Staff Report
SP-26-0006

Request: Site Plan to construct a new 120,000 sq.ft., 2-story medical office building with 600 parking stalls in a single phase on Lot LRK, LLC-3 of the Leon R. Kleinpeter Property with associated off-site regional stormwater management facilities

ST. GEORGE PLANNING COMMISSION
 SITE PLAN SUBMITTAL

DRAWING NO.
SP-3.0

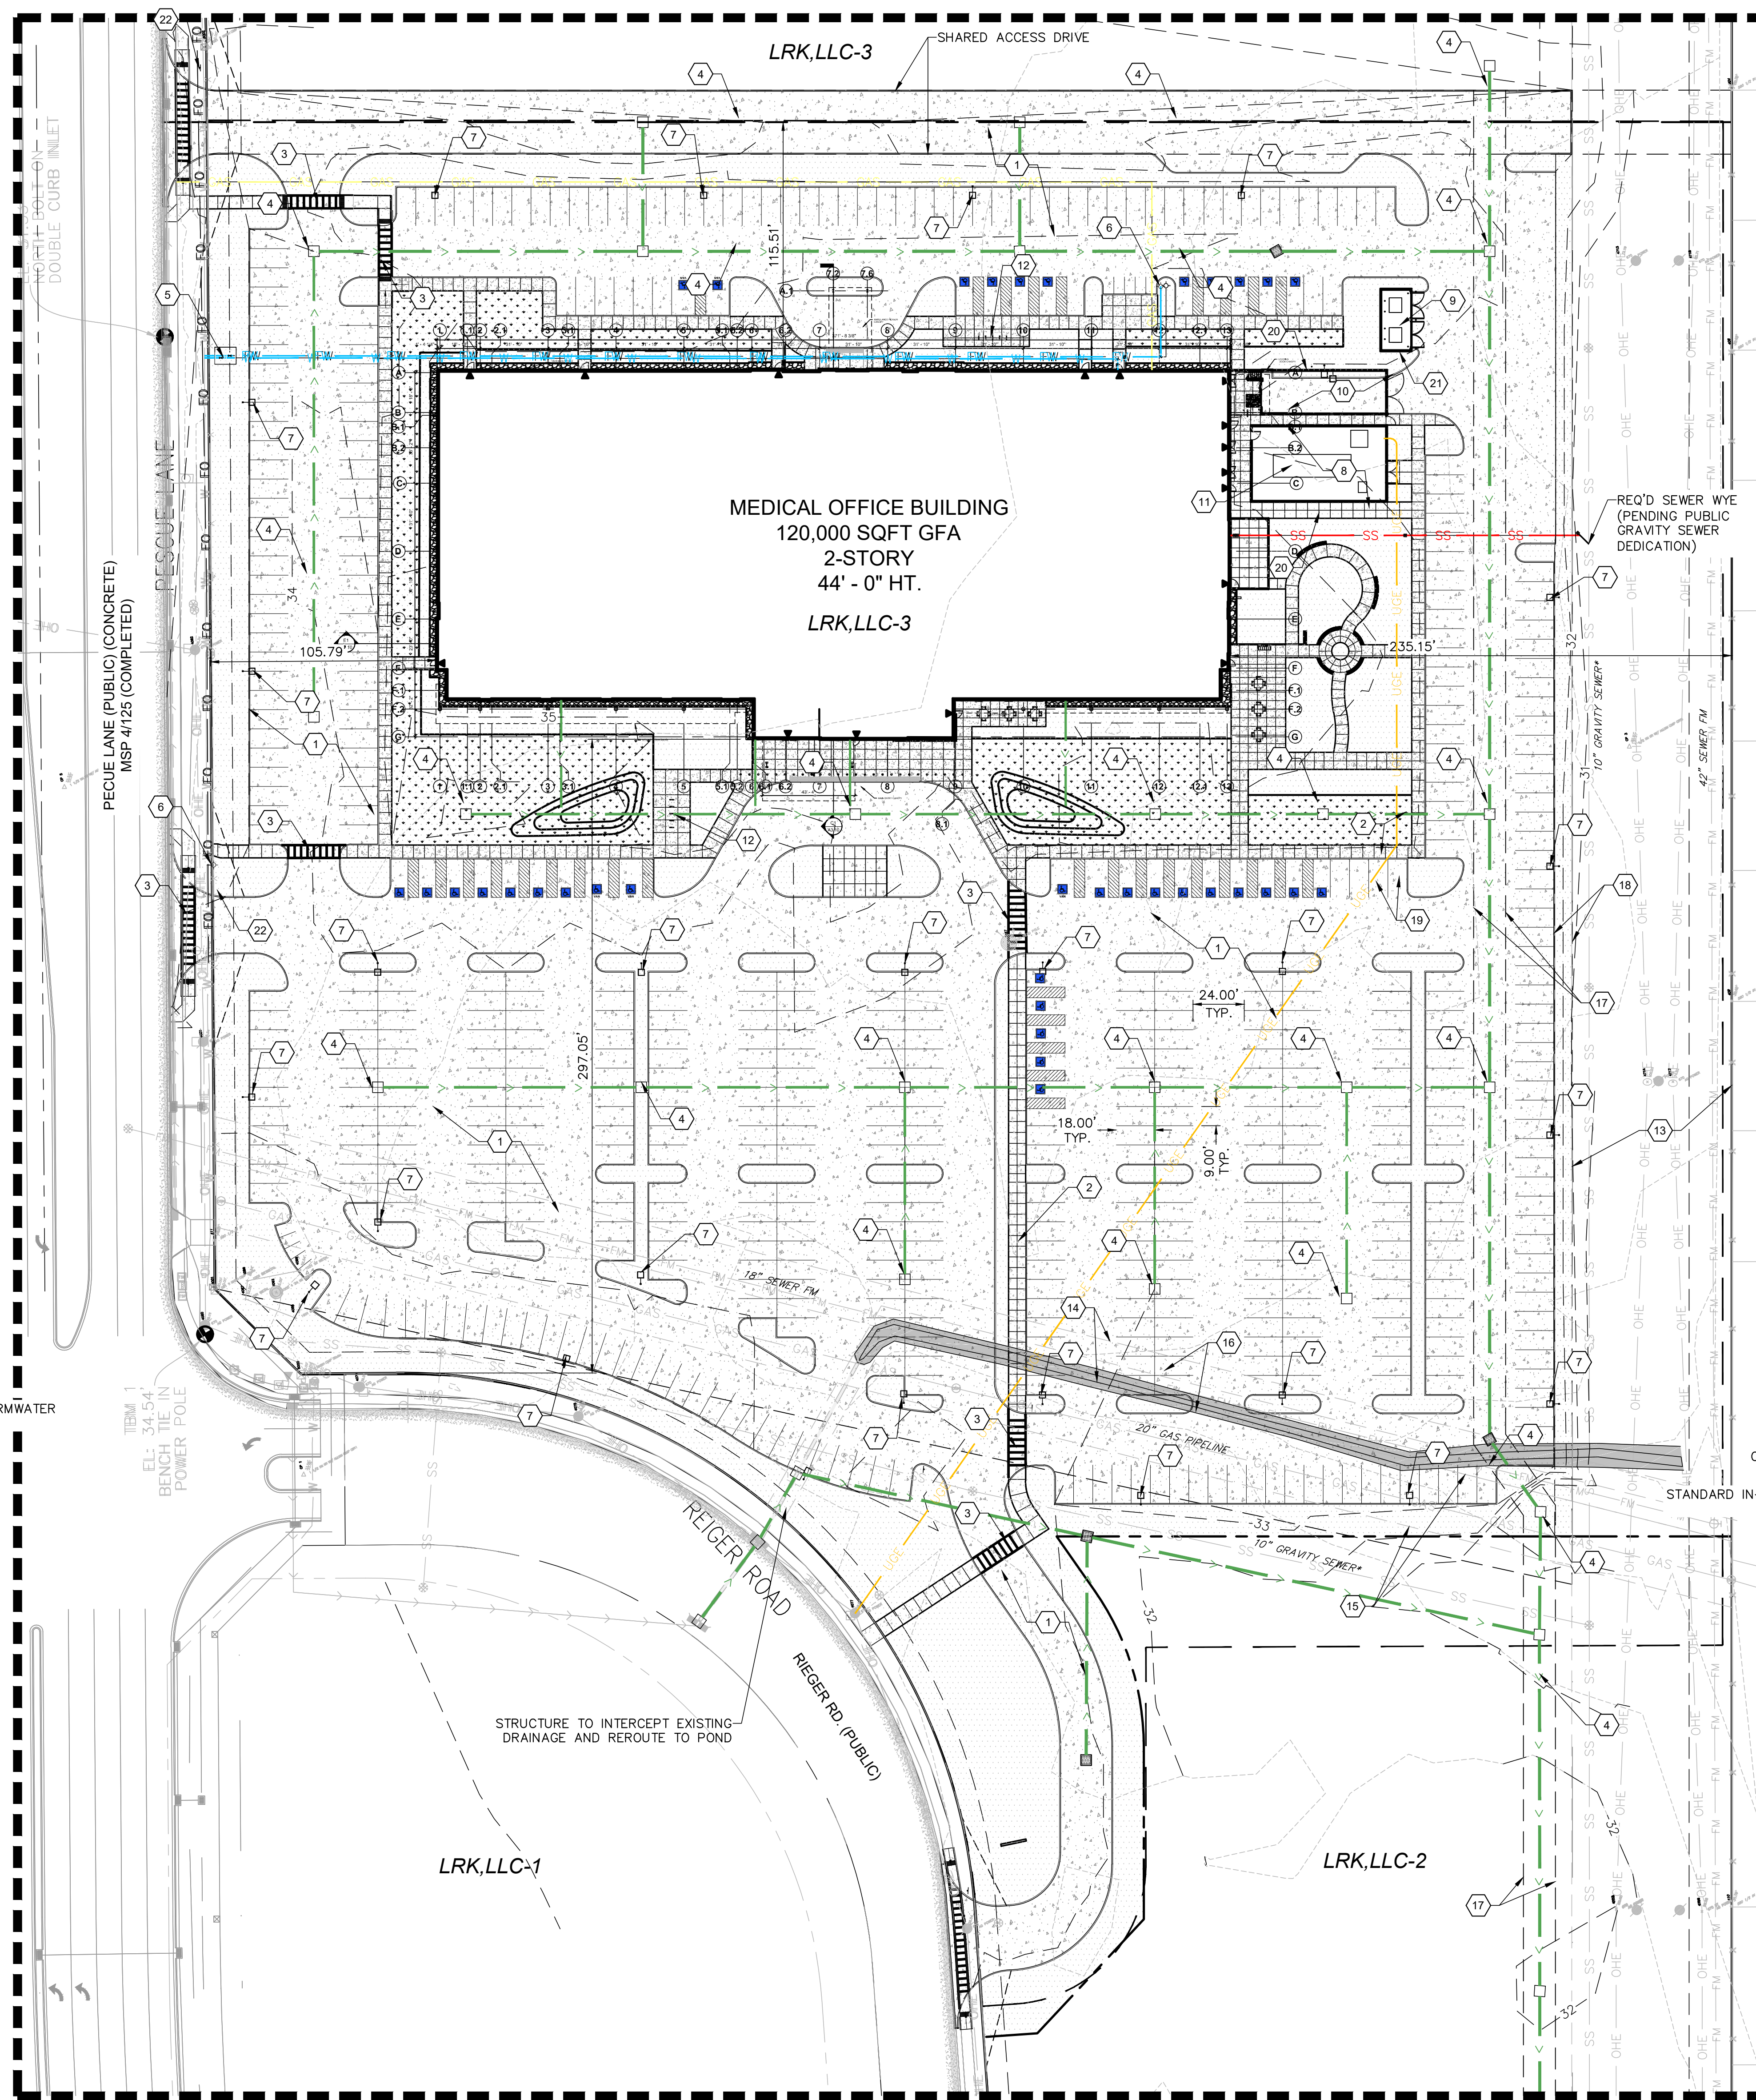
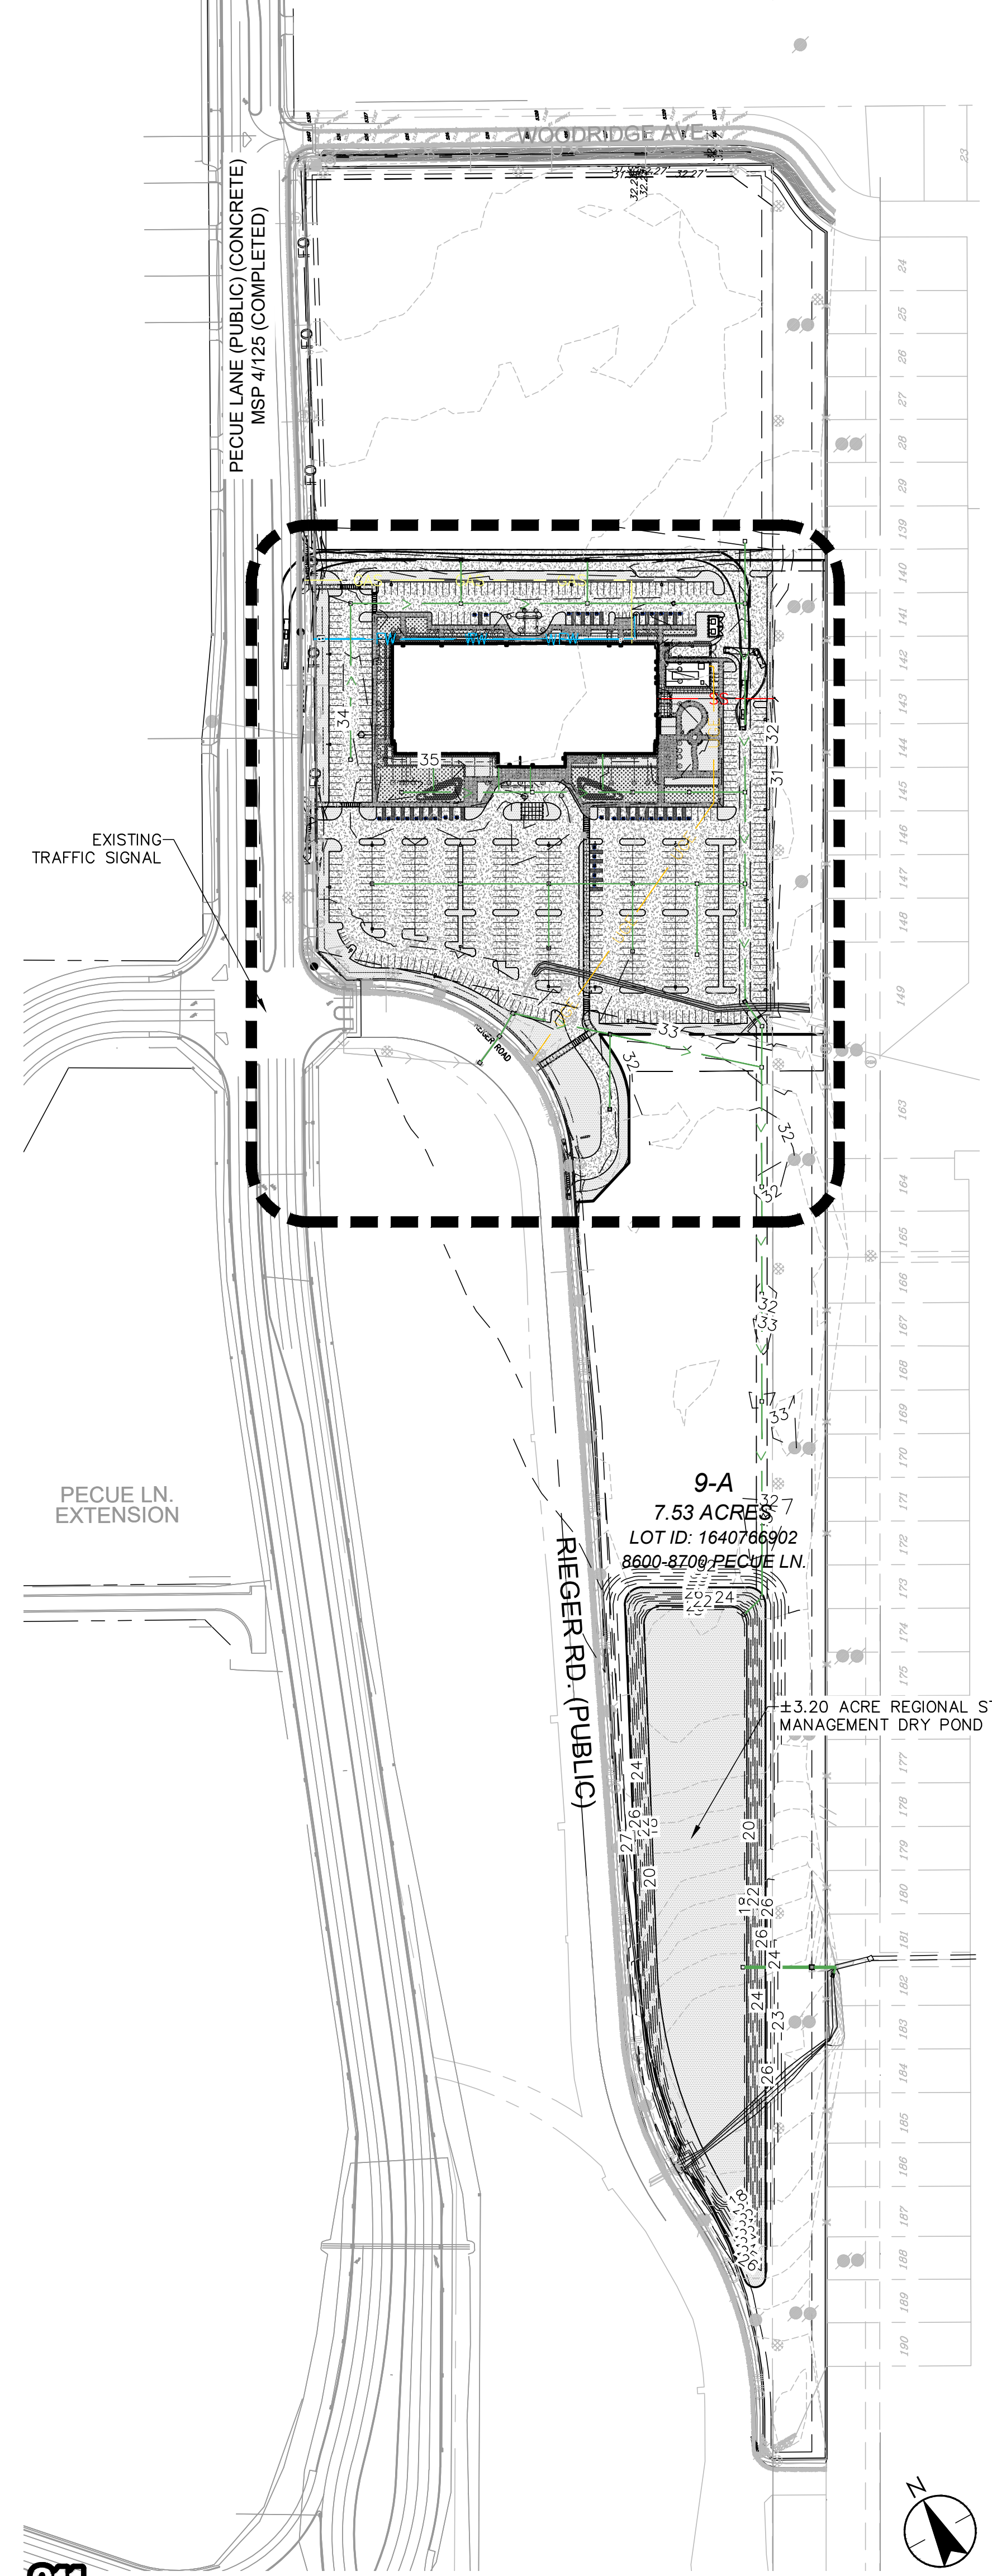
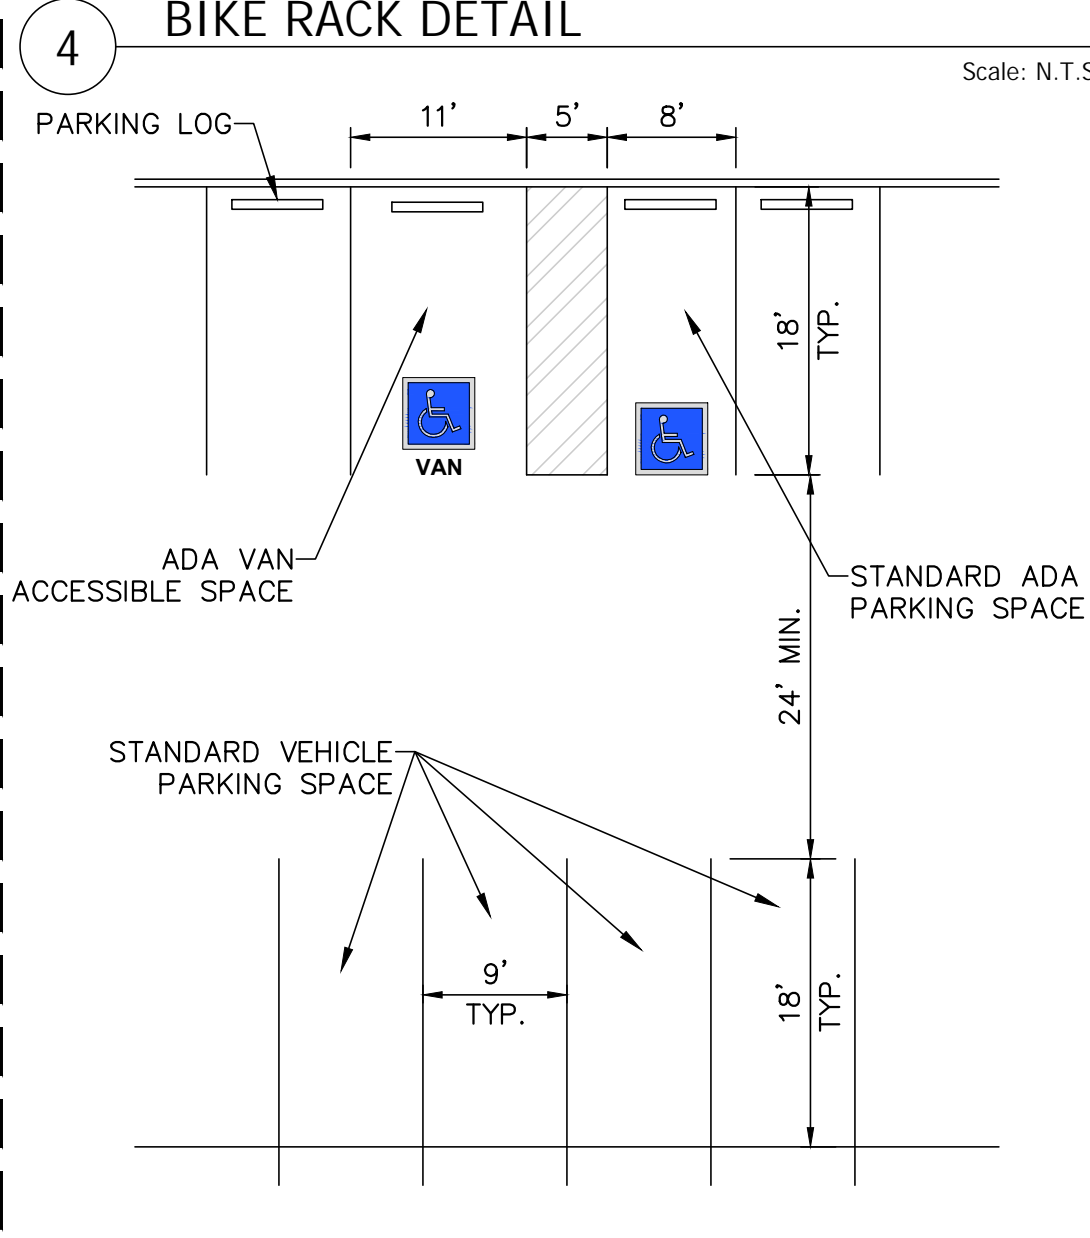
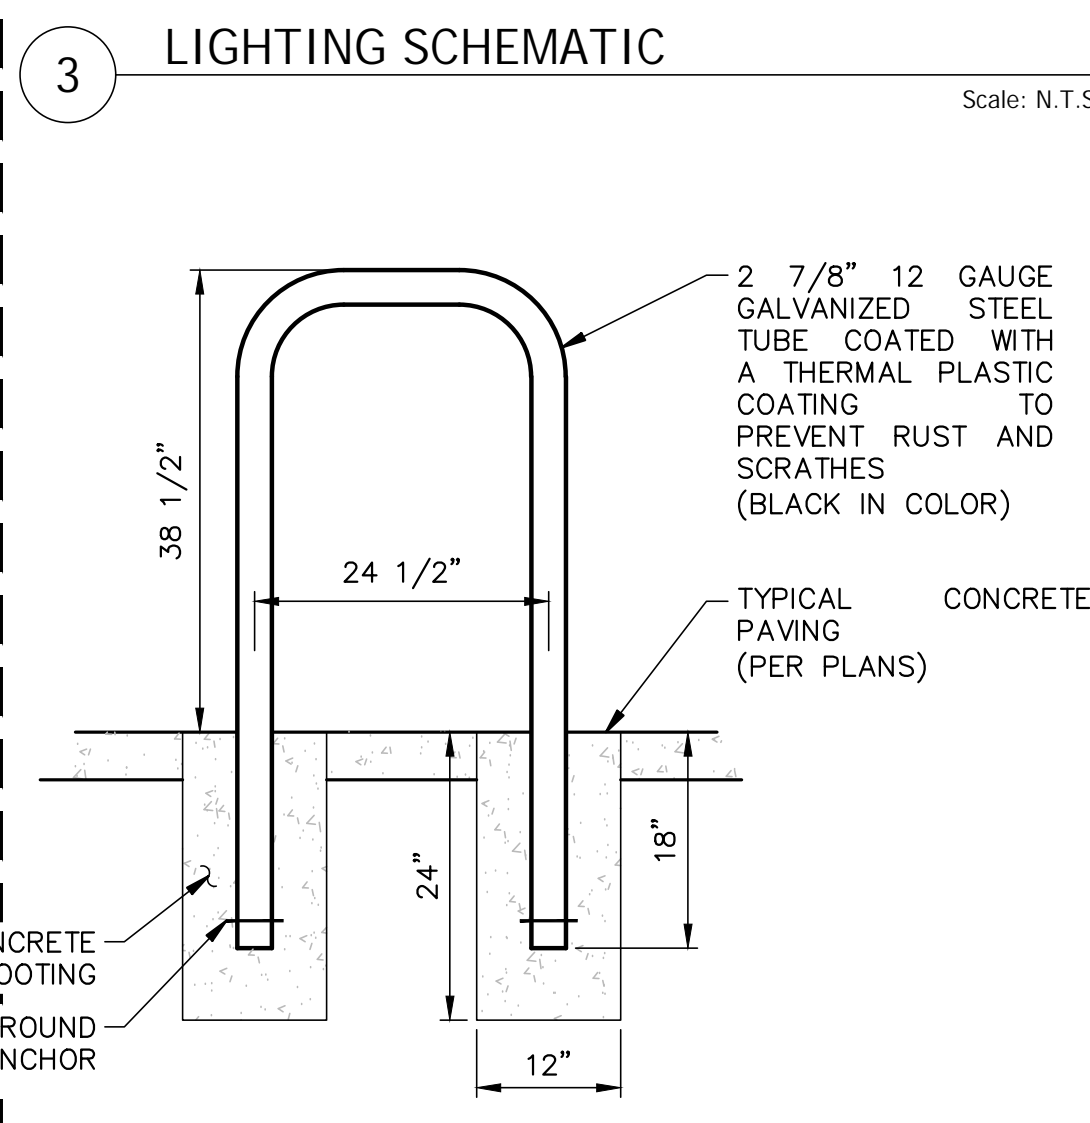
8. After review of the site plan access and circulation, the City's Engineering Department recommends the following:
 - To avoid unnecessary conflict points on Pecue Lane (closest to the signal at Rieger Road), only one (1) access drive shall be provided on Pecue Lane, as a shared access drive with adjacent Lot LRK, LLC-4.

- The applicant also indicated that access points are to be dedicated to staff only, delivery/ambulance, and visitor-only entrances in response to engineering comments. These restrictions with any type of access gates on this property would also create potential queuing on Pecue Lane. Any restrictions shall be shown on plans and reviewed prior to issuing permits.

- The proposed access connection to Rieger Road is acceptable, with the understanding that it may be modified or relocated in the future to facilitate a shared access arrangement with adjacent future developments, if determined necessary by the City.

- (1) Provide plans in compliance with the City Engineering Department’s recommendations for roadway access, including limiting access to the one (1) shared access drive on Pecue Lane and modifying the site layout as necessary to accommodate the revised access configuration;
